MIROMAR LAKES SHORELINE MANAGEMENT SYSTEM

MIROMAR LAKES

SHORELINE OPERATIONS DEVELOPMENT DISTRICT

SECTION 2 Response to South Florida

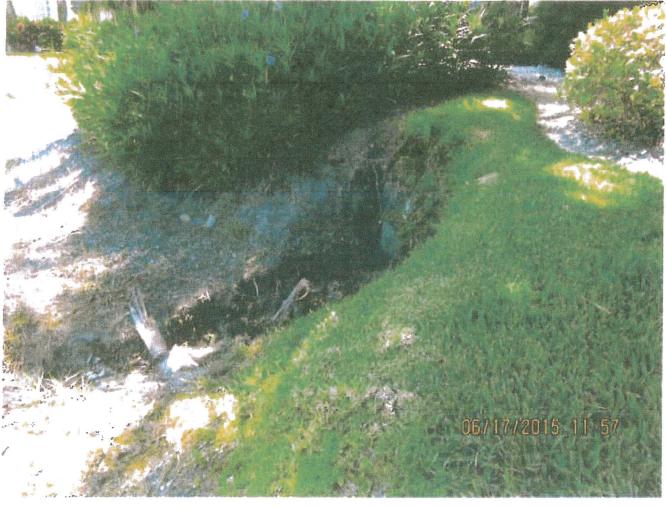
| Notes & Comments: Lake 6I - Erosion to the lake shoreline. Drop of approximately four (4) feet between lots. | |

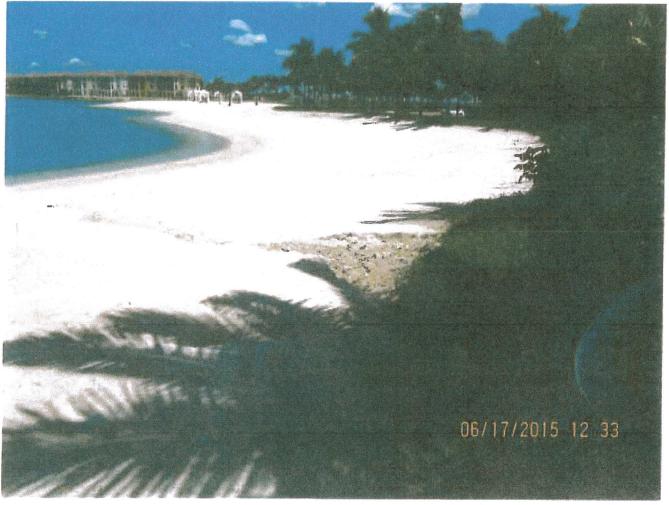
| Notes & Comments: Washout to the lake shoreline (beach easement) - due to the concentration of roof runoff. |

EXISTING DRAINAGE IMPROVEMENTS
ROOF DRAIN EROSION REPAIR DETAIL

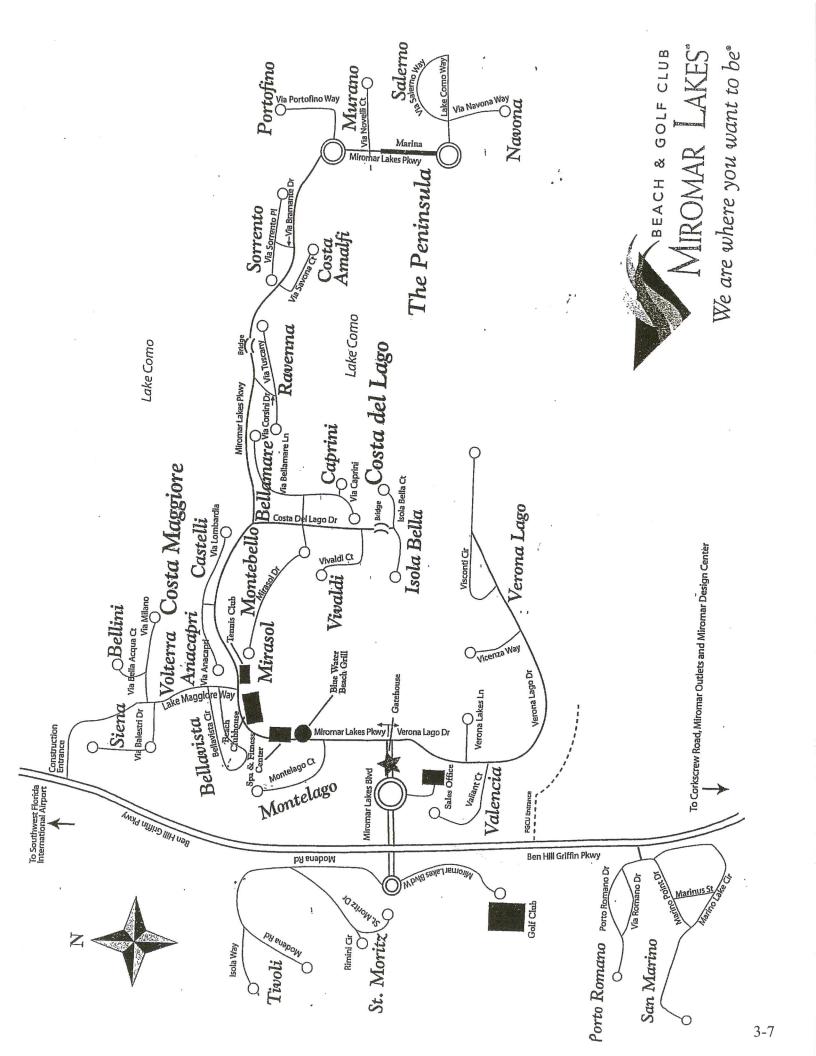
ROOF DRAIN INLET / LAKE OUTFALL DRAINAGE CONNECTION
